Surveillance Capsule B from Diablo Canyon Unit 1

A Review of Data reported in WCAP-19173-NP and its Implications

Consultant's report to the Diablo Canyon Independent Safety Committee

Date: 9 October 2026

Figure 2. CVN transition temperature curves for the Diablo Canyon Unit 1 surveillance weld (this is Figure 5-7 from [WCAP-19173]). Only data from the curve marked "5" (in orange) is new from Capsule B; all other data were previously reported.

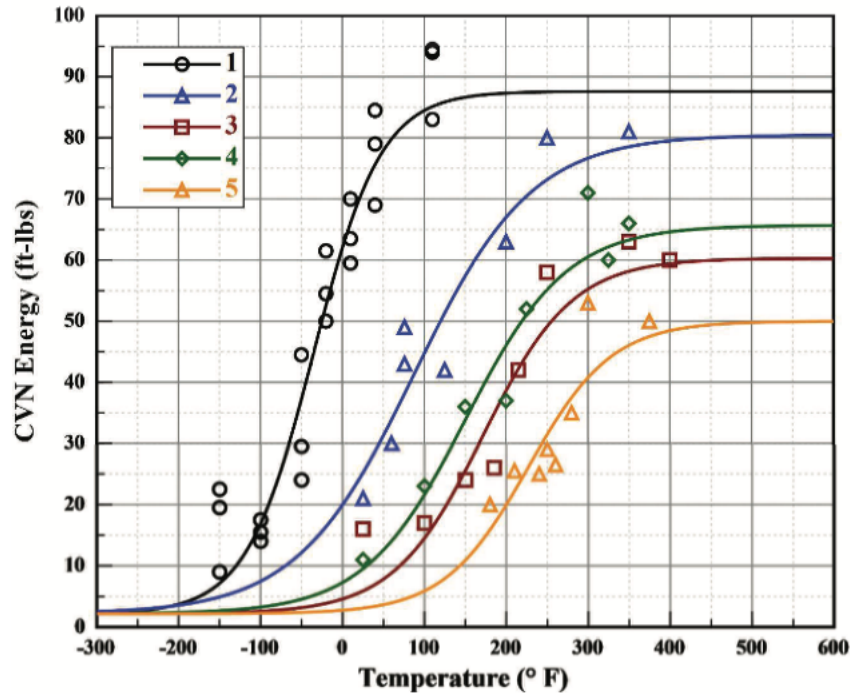
The Charpy transition curves for the Diablo Canyon Unit 1 surveillance weld and the surrogate weld of weld wire heat 27204 appear in Figure 2 and Figure 3, respectively. These figures are direct copies from [WCAP-19173]. Each symbol on these plots represents the result of an individual CVN test. Much of the data on these figures was available prior to Capsule B testing; only the curve marked "5" on Figure 2 and the curve marked "2" on Figure 3 were determined from Capsule B testing

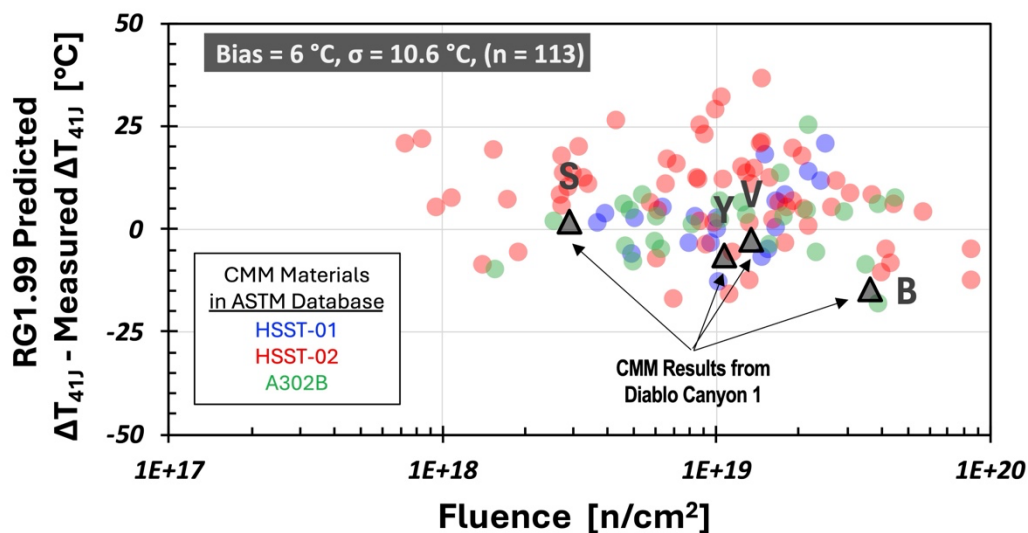
Today the scatter shown by available CMM data relative to [RG199-R2] predictions is best quantified using the database of surveillance measurements compiled in [ASTM Adjunct] and updated in 2022. Figure 8 shows these data as colorful dots and compares them to the results of the four CMM measurements for Diablo Canyon Unit 1, which are shown as black triangles. Figure 8 shows that the CMM data from Unit 1 fall within the scatter band of CMM test results from many plants as compiled by ASTM. Thus, these data fulfill this NRC requirement. This conclusion is consistent with that reported by Westinghouse in the Capsule B report [WCAP-19173].

Figure 9. PTS assessment for Diablo Canyon Unit 1 including data from Capsule B.

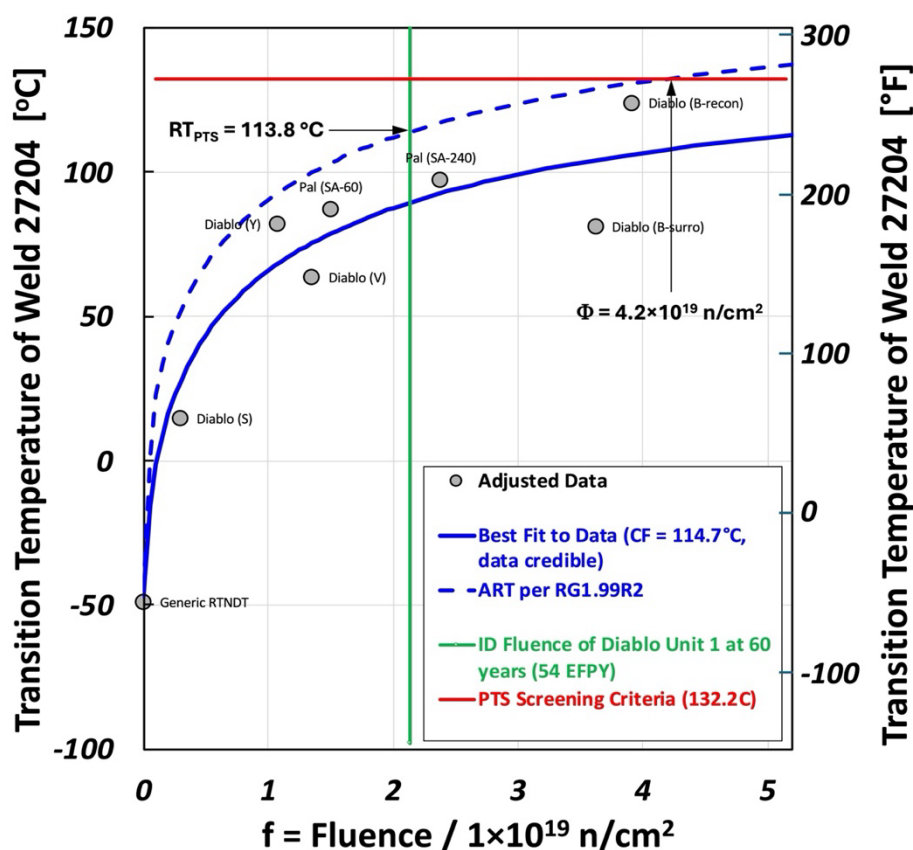
Figure 9 illustrates the results of a PTS assessment following the NRC's required procedure using all Charpy and RT_{NDT} data for weld wire heat 27204. This analysis includes the two new data obtained from Capsule B as reported in [WCAP-19173]. The available data cover a range of fluence to almost twice the value expected at 60-years, which meets the guidance of [ASTM E185-82], incorporated by reference into [10CFR50-AppH], that the final capsule test be tested as a fluence between 1- and 2-times the expected fluence at end of license.

indicates that it would take Unit 1 approximately¹¹ 118 calendar years of operation to reach this fluence. This expression of “years to reach the screening criteria” is intended to express the outcome of the analysis using units that are more accessible to the general public (years of operation) than the values of fluence that would be used in a report written for subject-matter experts.

These predictions are very similar to the prior PTS assessment, which was based on the five measurements available before Capsule B was tested [WCAP-17315]. That assessment was performed and reported in 2011 and was later confirmed by this consultant for the DCISC [Kirk Part 2].

Figure 10. Evolution of data for weld wire heat 27204 over time and resultant estimates of RT_{PTS} for Unit 1.

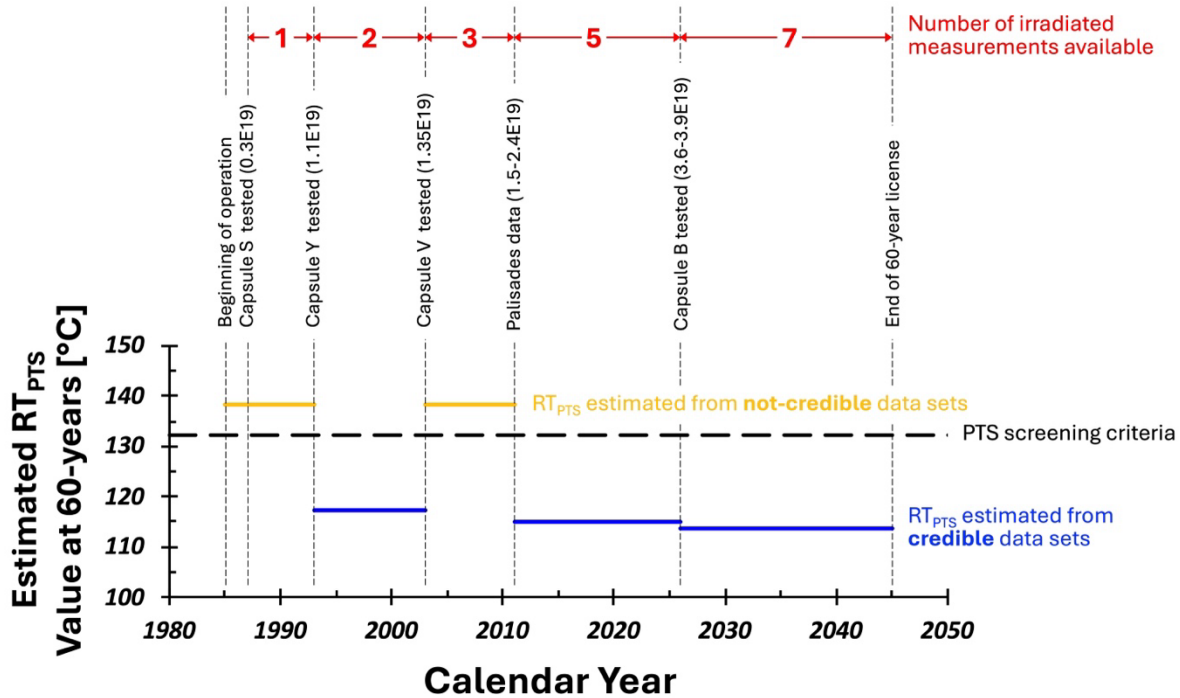
for all prior data states that have existed since the beginning of plant operation. These calculations were reported in [Kirk Part 2] and are summarized here in Figure 10. The horizontal axis on Figure 10 is calendar year. The numbers **in red** along the top of the figure give the number of irradiated T_{41J} and USE measurements that were available for weld wire heat 27204 and how this number has increased since Unit 1 was placed into operation in 1985. As stated previously these data have become available through surveillance capsule testing for Unit 1 and also through testing at the Palisades plant, which provided the sister-plant data. The **orange** and **blue** lines show the values of RT_{PTS} estimated from these data sets. **Orange lines denote RT_{PTS} estimates from not-credible data sets** while **blue lines denote RT_{PTS} estimates from credible data sets**. The **black dashed line** at 132 °C indicates the NRC's PTS screening criteria applicable to Unit 1.

- When the data set is evaluated as being "**credible**," (as it is today and has been since 2011), the estimated RT_{PTS} at 60 years is, on average, ≈ 17 °C below the PTS screening criteria. Consequently, the estimated number of years it would take to reach the NRC's PTS screening criteria exceeds considerably (by decades) the current license term of 60 years. The stability of this forecast occurs because, as illustrated in Figure 9, the measured ΔT_{41J} data follow a consistent trend that agrees reasonably well with the functional form of the ETC in [RG1.99R2].

As illustrated in Figure 10, the NRC's credibility criteria influences significantly the outcome of the PTS assessment for Unit 1. As stated earlier, the NRC's criteria is based on the number of data falling outside of a $\pm 1\sigma$ range from the mean prediction of [RG1.99R2]; if more than 32% of available data fall outside of this range the data set is deemed to be non-credible and the estimate of RT_{PTS} is intentionally biased in a conservative direction (i.e., increased) in that case.

Figure 11. PTS assessment of Unit 1 using the method of draft ASME CC N-914.

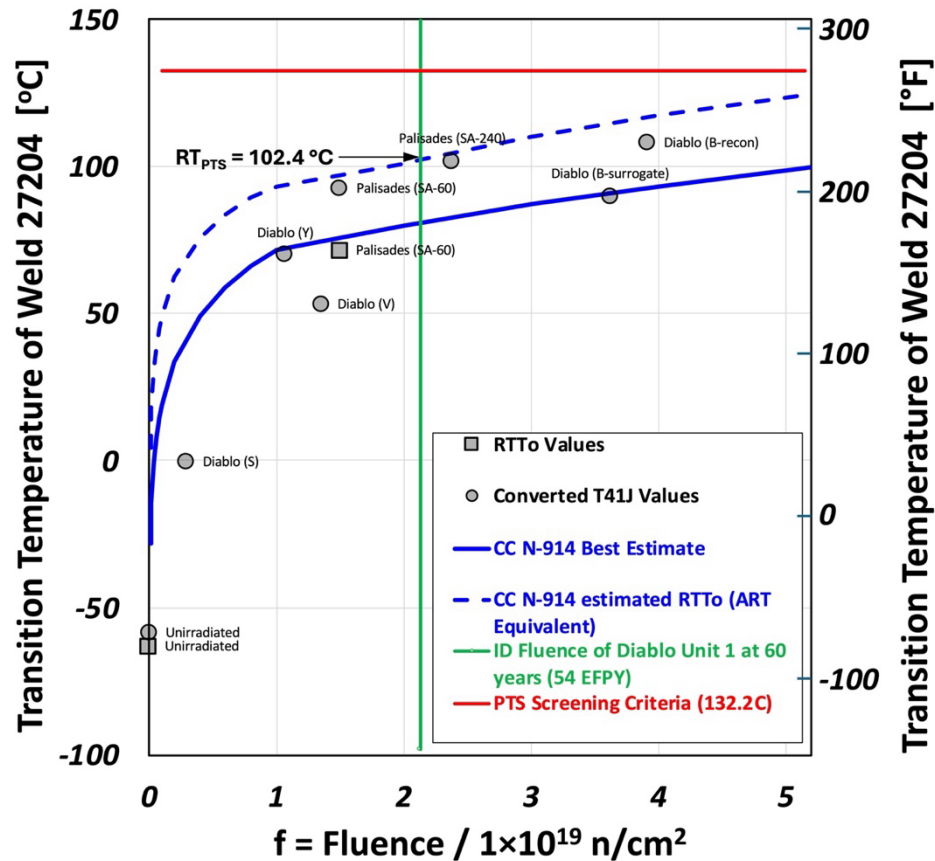
For the CC N-914 evaluation, the Charpy data for weld wire heat 27204 summarized in Table 4 are again used¹³ and are augmented by fracture toughness transition temperature (T_0) data reported for this weld wire heat in [MRP-127] (see Table 6). Figure 11 shows the result of this analysis, which can be summarized as follows:

The Margin in the CC-N914 varies somewhat with fluence. On Figure 11 the Margin appears graphically as the vertical distance between the dashed and solid blue curves.

Figure 12. USE evaluation using only weld wire heat 27204 surveillance data from Diablo Canyon Unit 1.

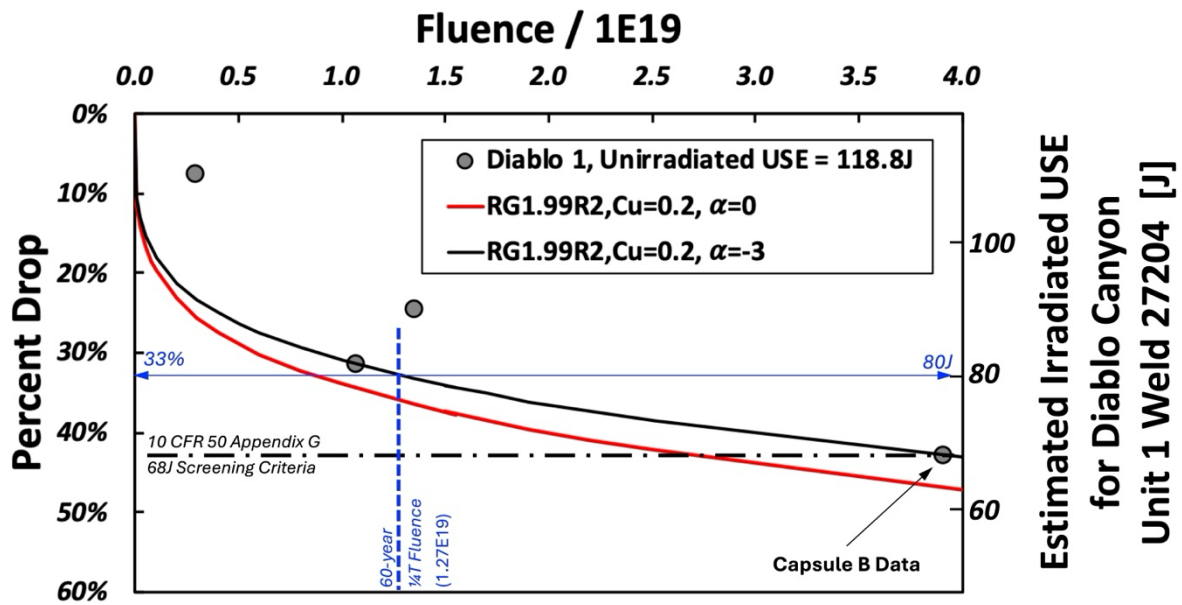
Figure 12 shows the four data for the Diablo Canyon Unit 1 surveillance weld analyzed according to the NRC's approach¹⁵, which was summarized in Section 3.3. The four circles show the data available prior to 2025 from capsules S, Y and V along with the new datum from Capsule B, which is labeled. The red curve shows the [RG1.99R2] USE prediction for weld wire heat 27204 without consideration of any USE data from Unit 1; this prediction is expected to lie below available data. The black curve adjusts the red curve to the data as required by the NRC's procedure¹⁶. The new data from Capsule B lies on this assessment curve established by data from Capsule Y, but does not alter it. The analysis results are as follows for the 60-year ¼-T fluence of 1.27×10^{19} n/cm²:

- Percent drop = 32.8% (rounded to 33% on the figure).
- Irradiated USE at 60 years = Unirradiated USE (118.8J) $\times$ (1-0.328) = 79.8J (rounded to 80J on the figure).

These results, which comply with the NRC's 68 J screening criteria, are indicated on the figure by blue lines. This analysis also indicates that the 68J screening criteria would be reached at a $\frac{1}{4}T$ fluence of 3.9×10^{19} n/cm², which exceeds the fluence at the end of the 60-year licensed lifetime by more than a factor of three.

Figure 13. USE evaluation using weld wire heat 27204 surveillance data from Diablo Canyon Unit 1 supplemented by data from the Palisades sister welds and from the surrogate weld, which are both also heat 27204.

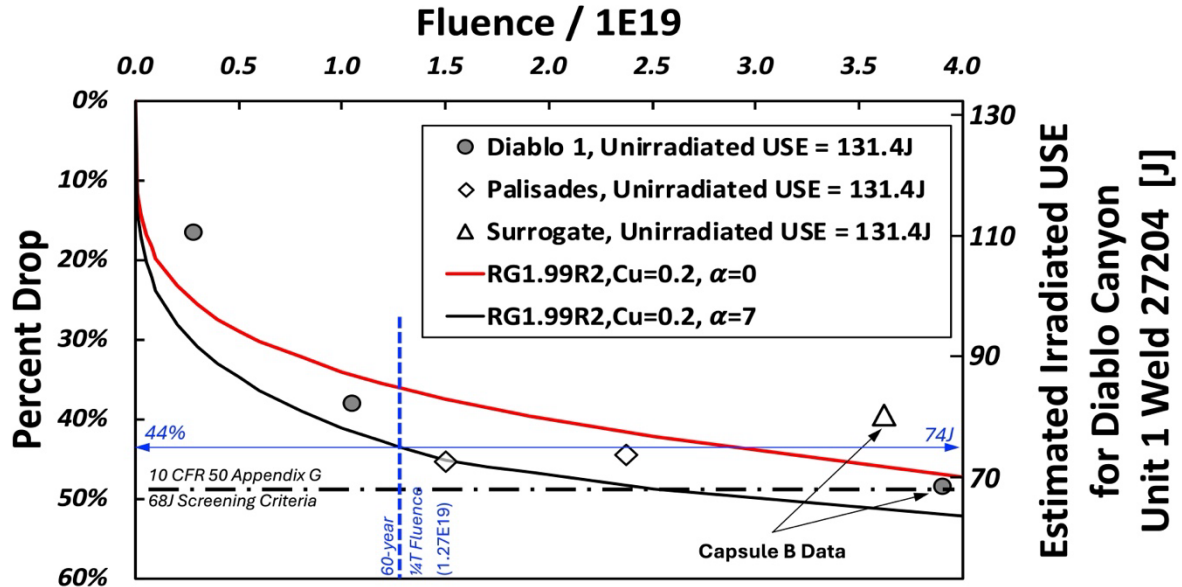
Figure 13 shows the seven USE measurements available for weld wire heat 27204, which includes the four data for the Diablo Canyon Unit 1 surveillance weld, two data from the sister plant weld, and one datum from the surrogate weld. Consideration of USE values from the sister and surrogate weld are not required by NRC procedures for USE evaluations. Nevertheless, this analysis was performed to estimate the USE after 60 years using all available data for weld wire heat 27204. As documented in a 2024 memo to the DCISC [Kirk 2024], analysis of this combined data set requires that the unirradiated Charpy data from the surveillance and the sister/surrogate welds be combined and fit together, which produces an unirradiated USE of 131.4J¹⁷.

The red curve shows the [RG1.99R2] USE prediction for weld wire heat 27204 without consideration of any measured USE data. The black curve adjusts the red curve based on the data as required by the NRC procedure. The Capsule B data from both the surveillance and surrogate welds lie above this assessment curve, whose position is established by one of the measurements from the sister plant. The analysis results are as follows for the 60-year $\frac{1}{4}T$ fluence of 1.27×10^{19} n/cm²:

- Percent drop = 43.4% (rounded to 43% on the figure).
- Irradiated USE at 60 years = Unirradiated USE (131.4J) $\times$ (1-0.434) = 74.4J (rounded to 74J on the figure).

These results, which comply with the NRC's 68 J screening criteria, are indicated on the figure by the blue lines. This analysis also indicates that the 68J screening criteria would be reached at a $\frac{1}{4}T$ fluence of 2.3×10^{19} n/cm², which exceeds the fluence at the end of the 60-year licensed lifetime by a factor of 1.8.
